TECHNICAL CONSULTANT RECOMMENDATION REPORT

DATE: May 15, 2026 Project No.: 940-80-25-12 (430)
SENT VIA: EMAIL

SUBJECT: Technical Review of the UCI GDE Study Report and Recommendations for Next Steps

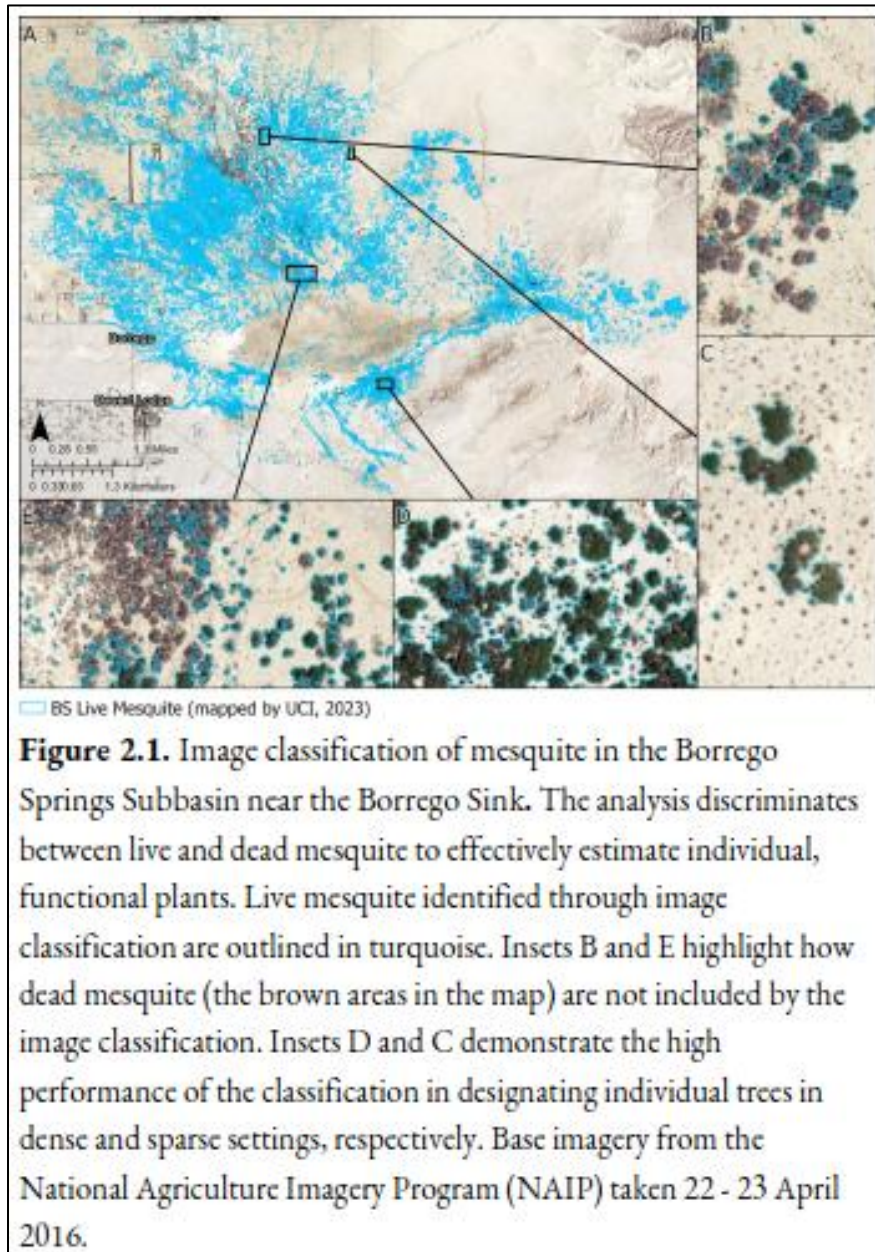
- *BAS determination: Partially Met*
 - The mapping approach of the live Mesquite tree canopy using image classification in ArcGIS Pro appears to produce reasonable results.
 - The resulting maps represent an improved understanding of locations of live Mesquite tree canopy in the BS Mesquite Bosque as of 2016, which establishes a “2016 baseline.”
 - However, the mapping approach should be validated by a remote-sensing specialist.
- Recommendations:
 - The mapping approach in ArcGIS Pro appears to be repeatable and objective, and if so, could be used as a monitoring technique for change detection of the extent and health of the live Mesquite tree canopy over time.
 - Before using this mapping approach for change detection over time, an independent remote-sensing specialist should evaluate and validate the approach and offer any recommended adjustments.

Figure 2.7. Mesquite bosque habitat polygons (green) overlaid on the depth-to-groundwater raster. Mesquite trees near the Borrego Sink are found at groundwater depths ranging from 22.1 - 134.0 ft bgs in Fall 2024.

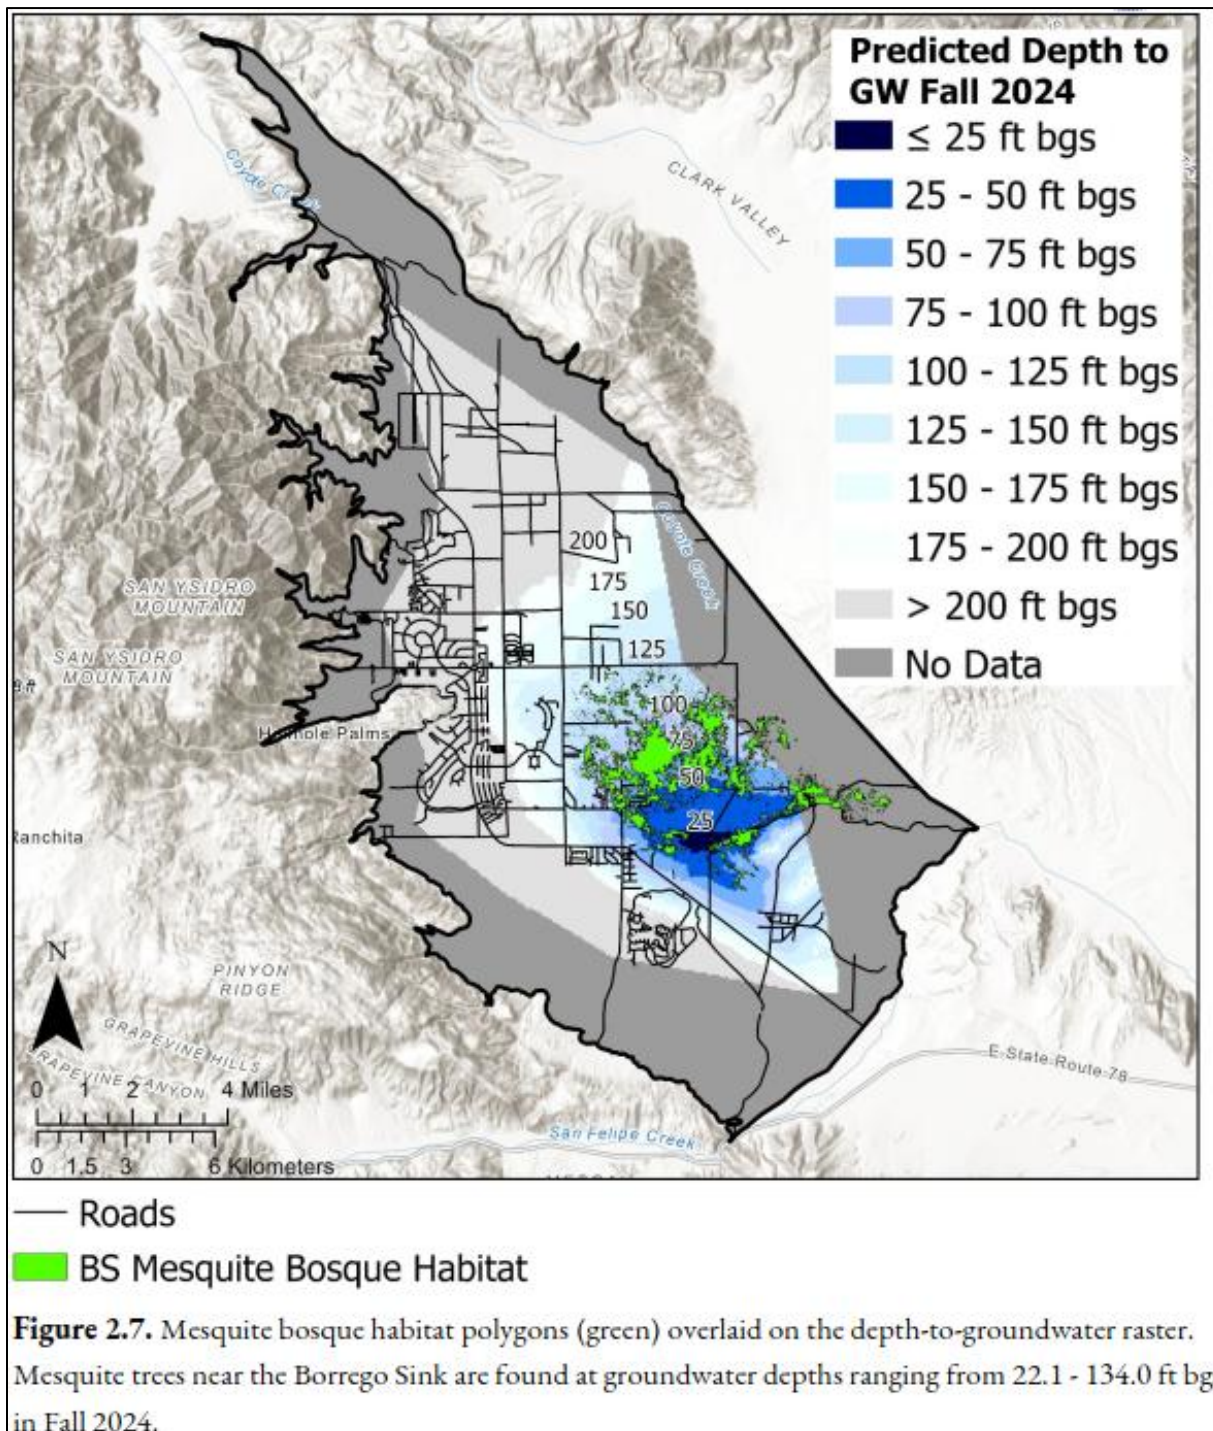
- *BAS determination: Partially Met*
 - This mapping technique provides a reasonable first-order estimate of depth-to-groundwater in the vicinity of the BS Mesquite Bosque. However:
 - The Watermaster’s groundwater-elevation raster was generated based on limited field measurements because wells are sparse within the BS Mesquite Bosque area.
 - The groundwater-elevation raster was generated for specific Watermaster purposes to characterize basin-wide groundwater conditions within the regional aquifer system (e.g., change in groundwater storage and groundwater flow directions).

Figure A3. Field collected soil moisture averaged across the two replicate samples collected for each depth. The triangle represents the average across depths while the error bars indicate the standard error.

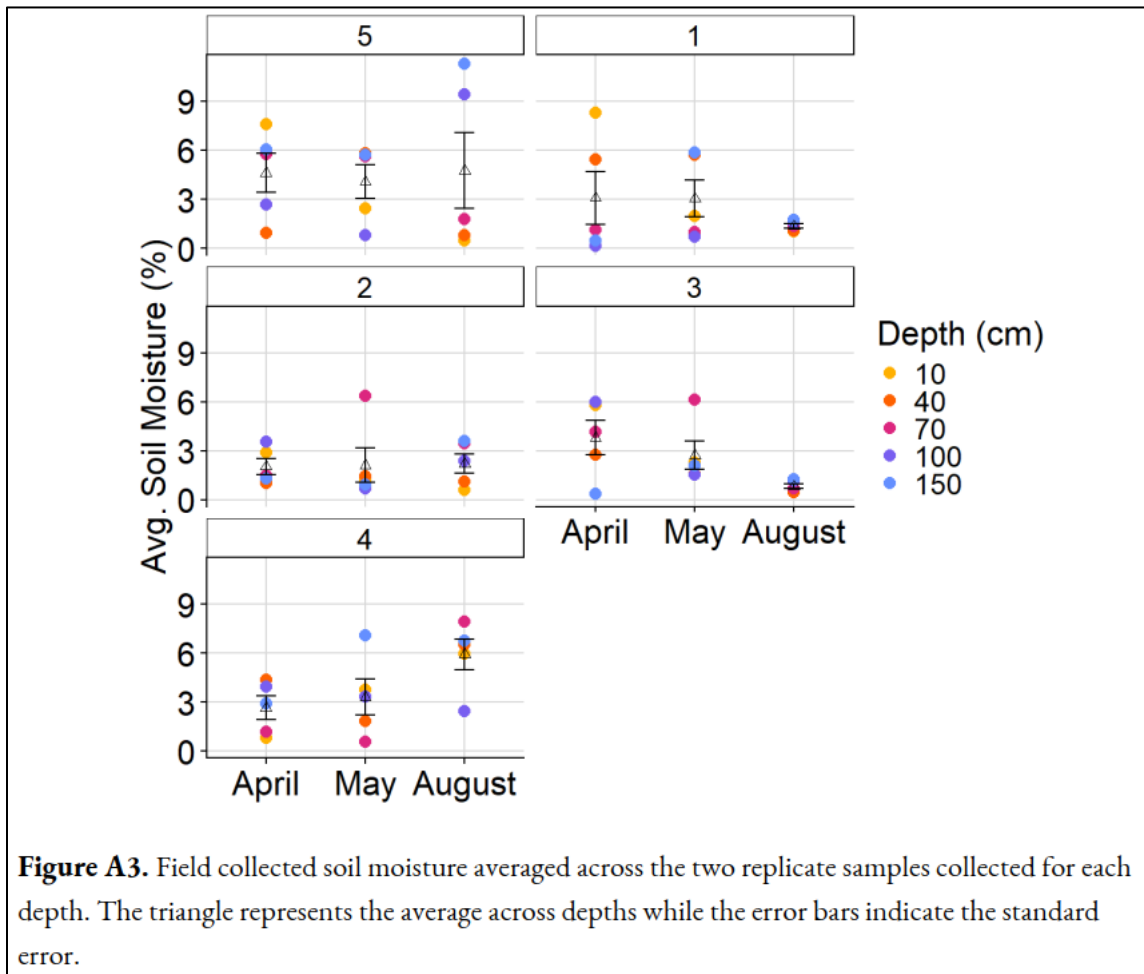
- **BAS determination: Not Met**
 - Soil moisture measured by volume (Figure A.2) is mathematically greater than soil moisture measured by weight (Figure A.3), so the two soil moisture time-series charts in the report (and shown above) cannot be directly compared. Nevertheless, soil moisture less than 10 percent, by weight or by volume, is representative of relatively dry soil conditions, as stated in the report.

- Mesquite trees are adapted to arid desert environments, and their roots can access soil moisture that is less than 10 percent by weight or by volume.

- Observations of progressively declining soil moisture throughout the dry season could be caused by soil moisture evaporation, evapotranspiration by the shallow plant roots, or both.

Figure 2.17. Leaf water potential in 2023 (top panel) and 2024 (bottom panel) across the three sampling periods. The points represent raw data, the black triangles indicate the mean, and the black error bars show the standard error. MPa: Megapascal

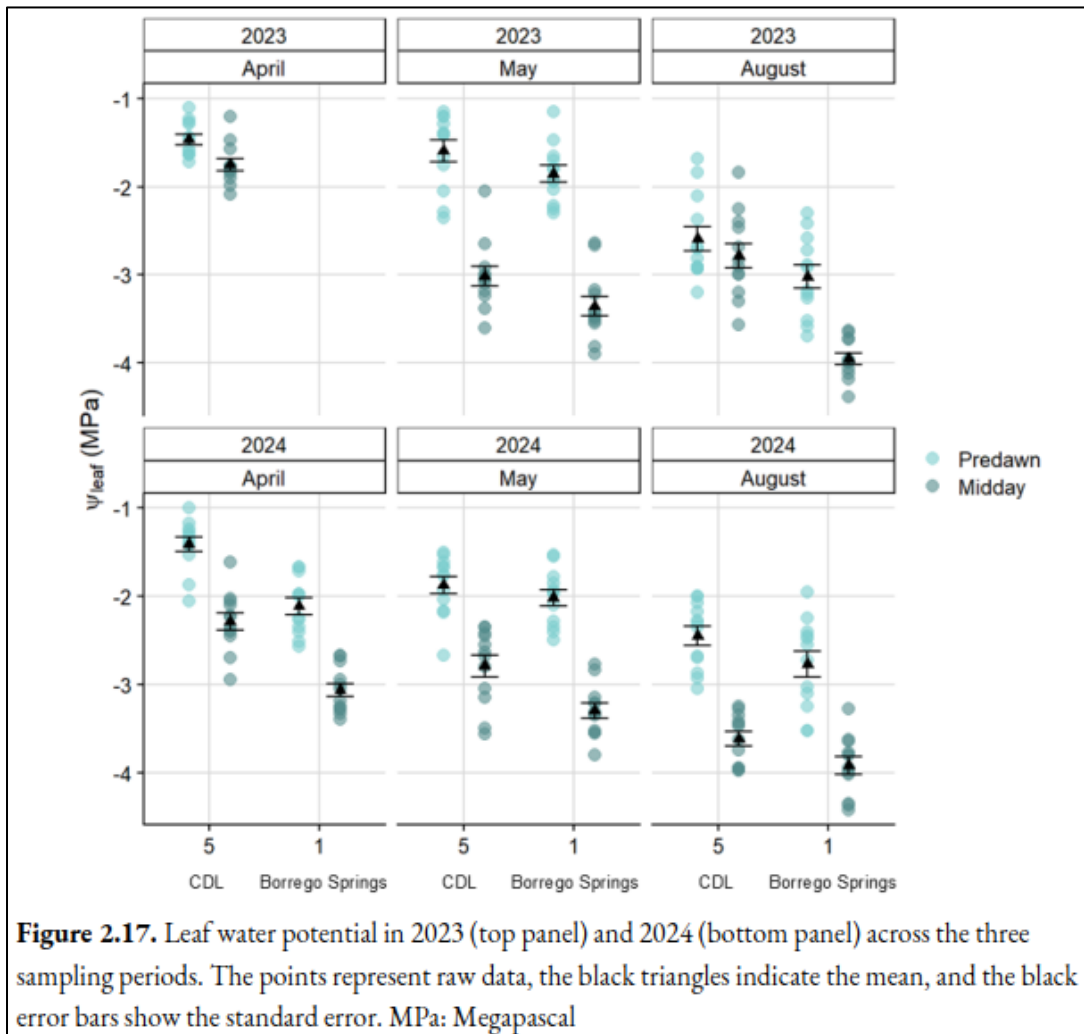
- However, we disagree with the conclusion of the study that these data necessarily indicate that the Mesquite trees are using the regional aquifer. An alternative explanation is that the Mesquite trees at the BS Site are using deeper soil moisture (>5 ft-bgs) which could explain:

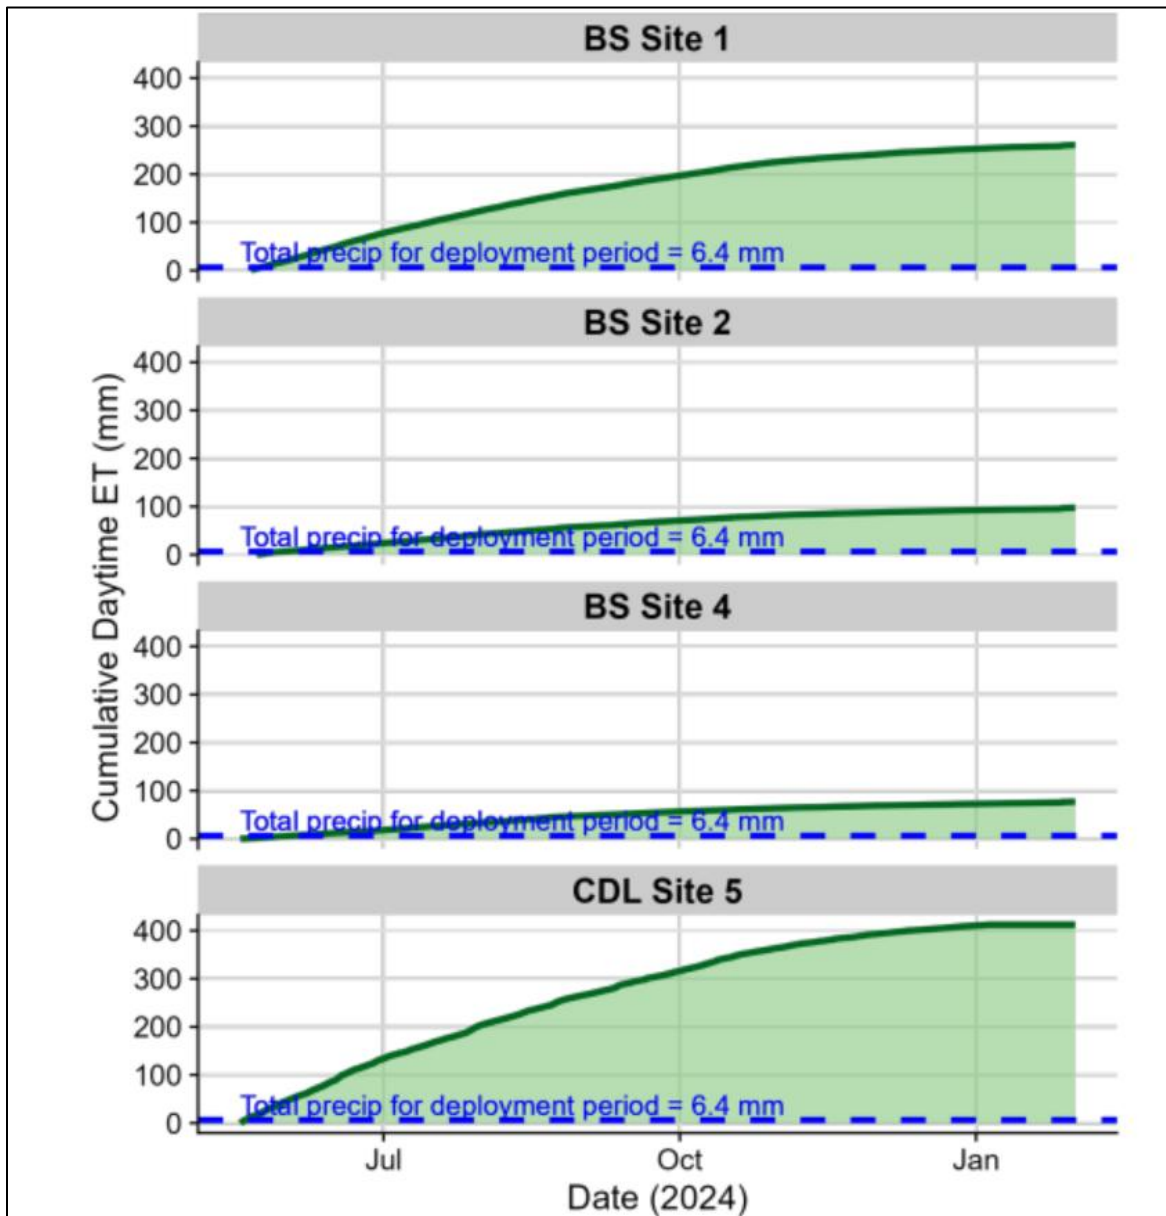
- **BAS determination: Partially Met**
 - We agree that the ET rates measured by the sensors are greater than the rates of direct precipitation; and hence, other source(s) of water must be necessary to satisfy the measured ET rates in the BS Mesquite Bosque over the dry, hot growing season.

- However, we disagree with study conclusion that the ET sensors provide direct evidence of groundwater use by Mesquite trees. The other source(s) of water could be:

- The report does not describe the accuracy of the ET sensors, considering that: (i) other plant species are present; (ii) atmospheric turbulence and mixing from other areas; (iii) lack of match with other ET monitoring methods (OpenET, CIMIS, etc.).

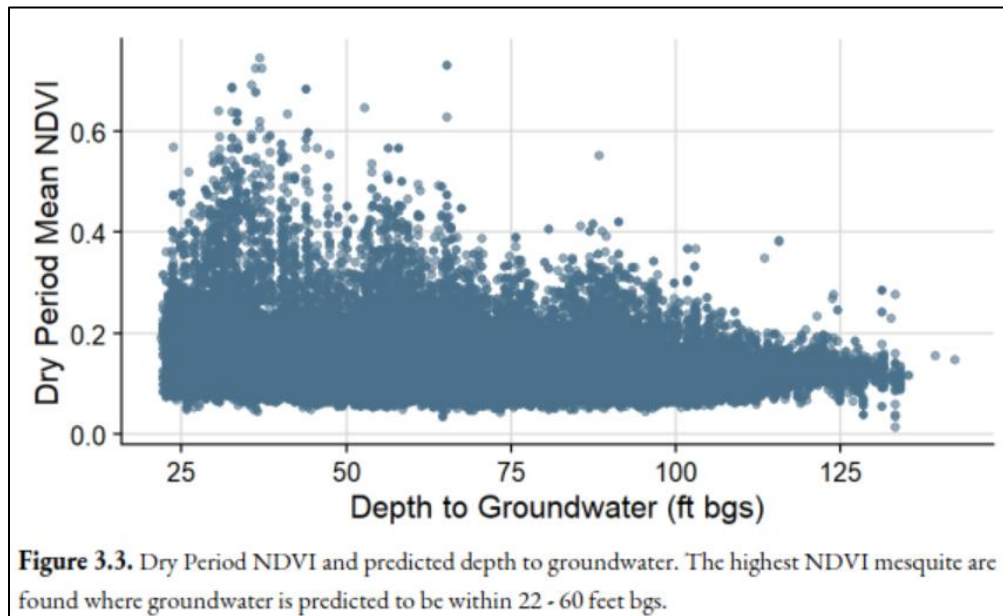
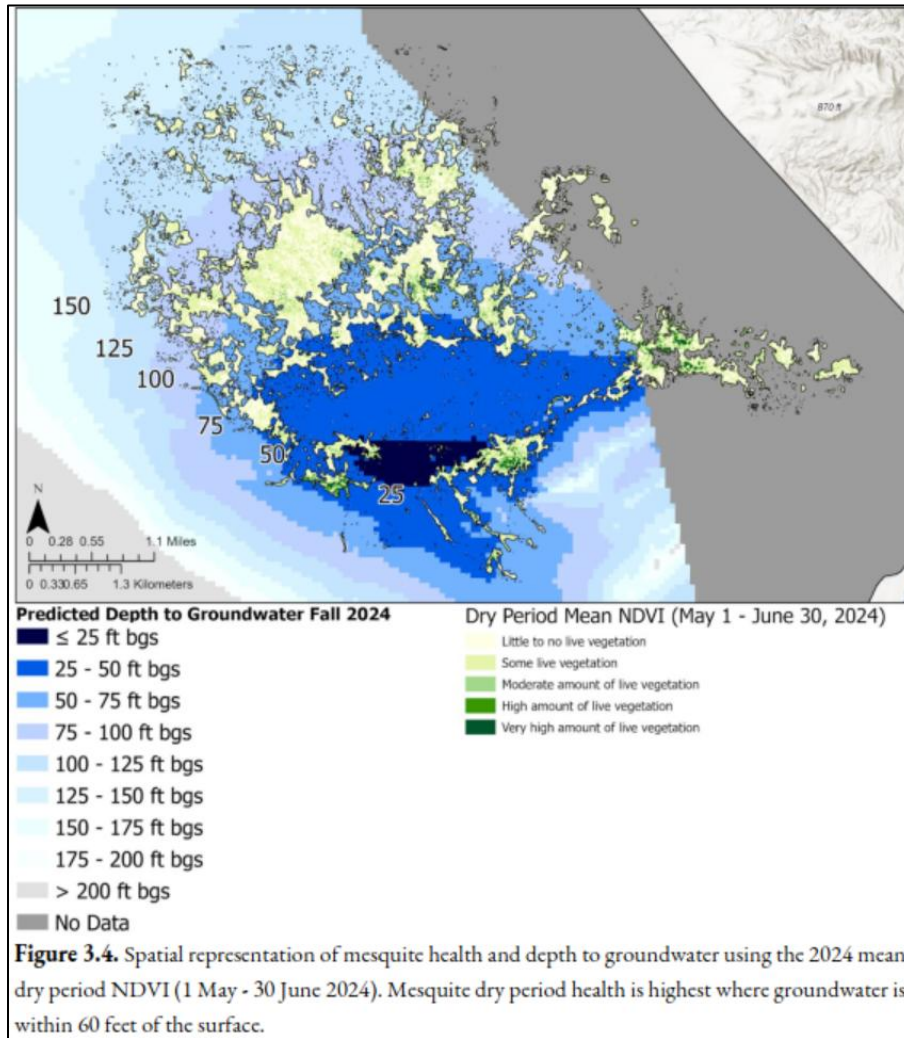
- **BAS determination: Not Met**
 - Figure 3.4 indicates that the more healthy, dense stands of Mesquite trees occur directly surrounding the Borrego Sink. This spatial pattern of healthy Mesquite trees is likely due to greater access to the various water sources in these areas, including:

- Both above.
 - **Data Gaps:** Currently, there are too many data gaps to establish numeric minimum thresholds for groundwater levels, including:
 - *A paucity of measured depth to the groundwater table and its capillary fringe.* As noted earlier in this memorandum, depth to the regional groundwater table is not accurately known in some areas of Figure 3.4. This is particularly true in the areas of the healthiest stands of Mesquite trees surrounding the Borrego Sink due to a lack of monitoring wells. In addition, the thickness of the capillary fringe above the

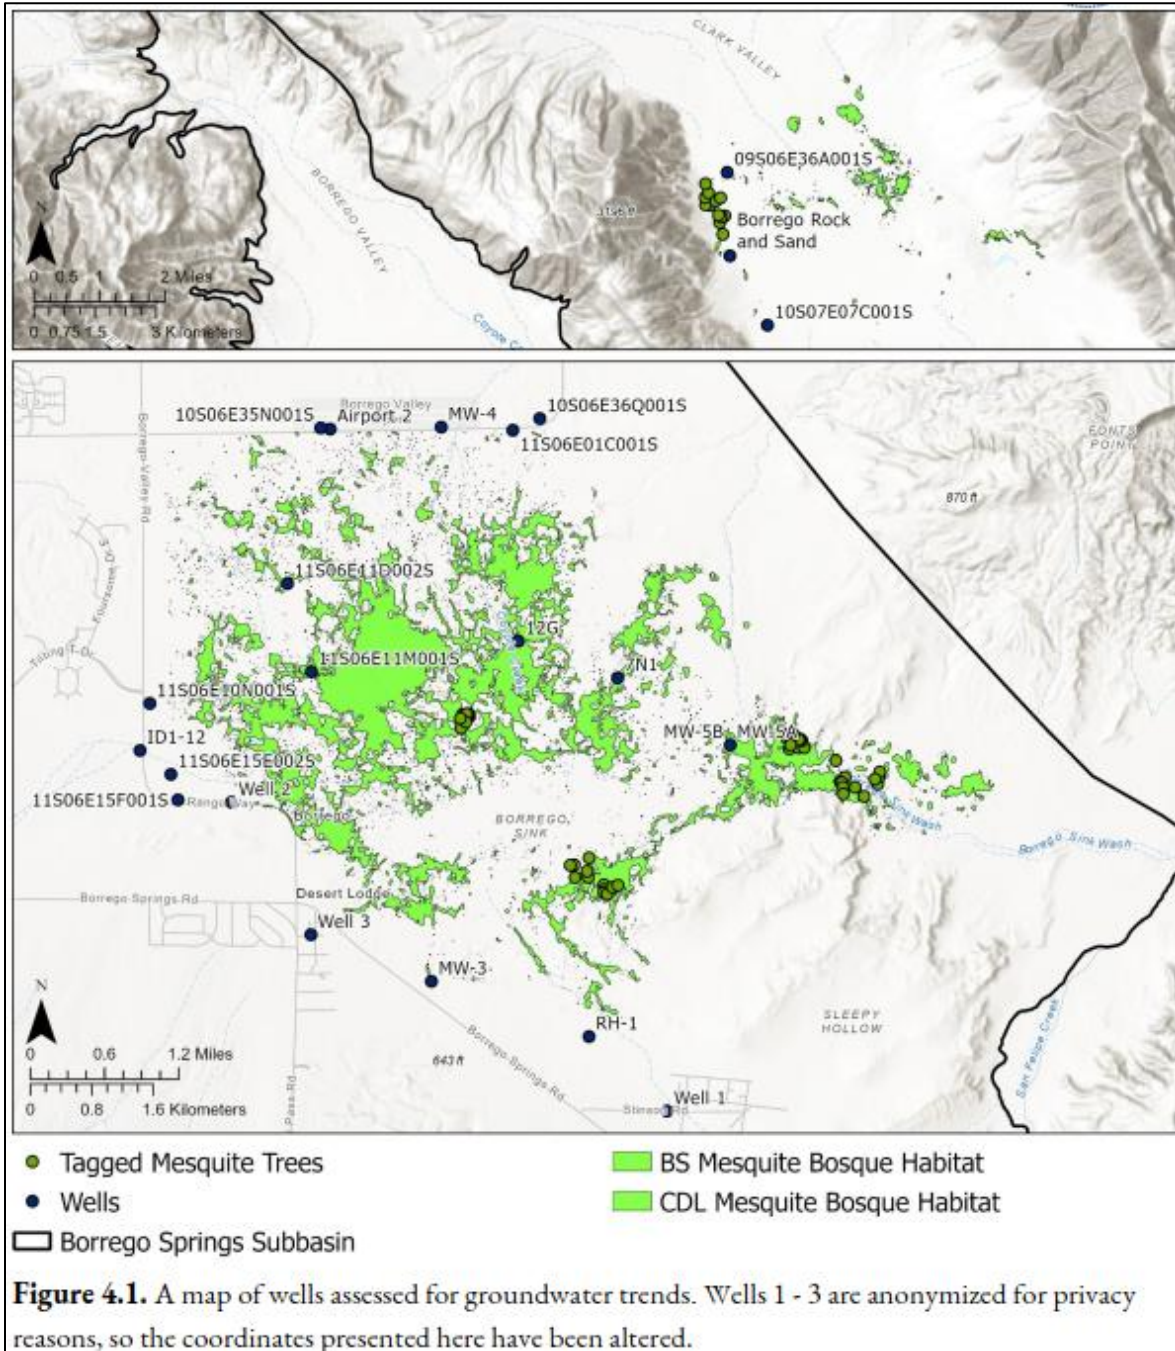
- We disagree with conclusion of the study that current declines in groundwater levels are responsible for current trends in degradation of the BS Mesquite Bosque. There are other alternative explanations, such as the recent relatively dry climate that could be adversely affect Mesquite trees that do not have access to the regional aquifer system.

- Track changes in groundwater levels over time compared to Mesquite tree health. Such data would be useful at the site level, as well as at the regional level, to:

- Assist in preparing more accurate rasters of depth-to-groundwater across the BS Mesquite Bosque.
 - Assist in understanding the current and ongoing cause-and-effect relationship between groundwater-level changes and Mesquite tree health.
